Officers direct referral report (s87F) for the two notified resource consent applications submitted to Greater Wellington Regional Council which form part of the North Kumutoto Precinct Project

Summary of resource consents sought from GWRC for the North Kumutoto Precinct Project

Report prepared by:	Doug Fletcher	Resource Advisor, Environmental Regulation		31/03/2015
Report peer reviewed by:	Christopher Fern	Resource Advisor, Environmental Regulation		31/03/2015
Report approved for release by:	Alistair Cross	Manager, Environmental Regulation		31/03/2015

Figure 1: Sea level projection for Wellington. Currently on trend for a 1.0 m rise by 2115 [1].

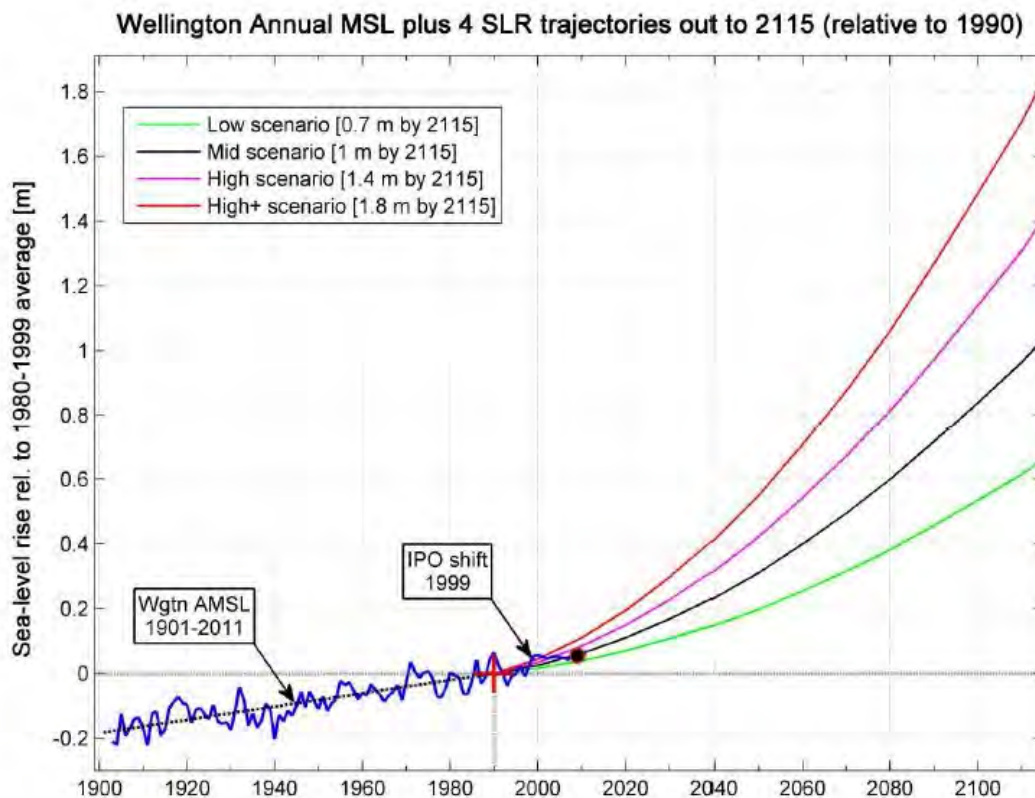
There has been considerable analysis of eustatic sea level trends, both globally and around New Zealand using historical tide gauge data and more recently with remote sensing via satellite altimetry. The long term global average from tide gauges is *ca.* +1.7 mm/yr. More recent satellite altimetry measurements show that since 1993, this rate has increased to 3.1 mm/yr. It is unclear whether this change represents an acceleration in the long term rate, but presently relative sea level at Wellington is tracking toward a rise of 1.0 m by 2115 (Fig 1). The assessment accepts this figure and incorporates it into the ground floor level.
